## VANGUARD Hardware Advisory Notice Release 6.1.T03A

This notice describes a revision change on the Vanguard Quad FXS card created by a manufacturing change in the SLIC chip design. Platforms: Vanguard 6435, 6455 and 340.

**Figure 1. Revision Number Label**

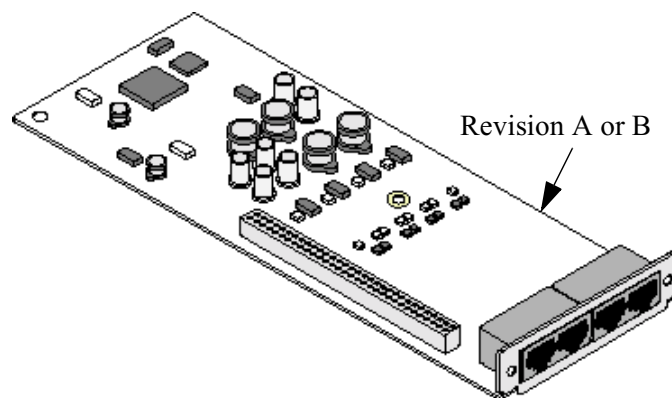
A manufacturing change in the SLIC chip design required the Quad FXS card to be revised from A to revision B. If you have a revision B Quad FXS card a 6.1 software patch is required (6.1.T03A). The Quad FXS revision B cards are not being recognized by software older than 6.1.T03A.

The arrow in Figure 1 shows the location of the revision label, located on the back right side of the Quad FXS card.
